# SERVICE BULLETIN

## **INFORMATION UPDATE — 1982/ALL MODELS**

## 1982 FLT Windshield Mounting Screws

M-845

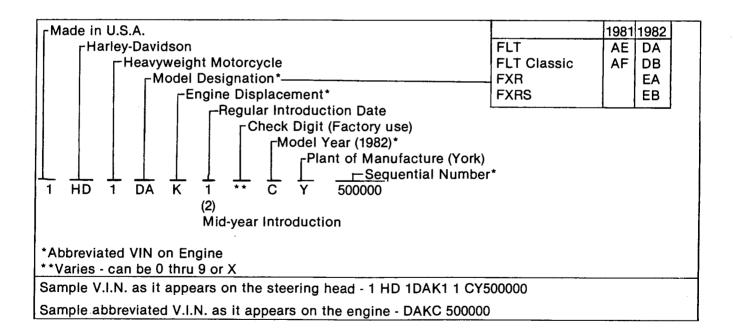
In 1982 Sportsters, a lower compression ratio has been achieved through the use of a thicker head gasket. This permits the use of regular grade leaded fuel, 89 pump octane.

Current Service and Owner's Manuals recommend the use of unleaded premium fuel. Testing has shown that prolonged use of unleaded fuel can have an adverse affect on valve train components. For this reason, we recommend using only regular grade leaded gasoline.

Please advise your customers of this altered recommendation against the use of unleaded fuel.
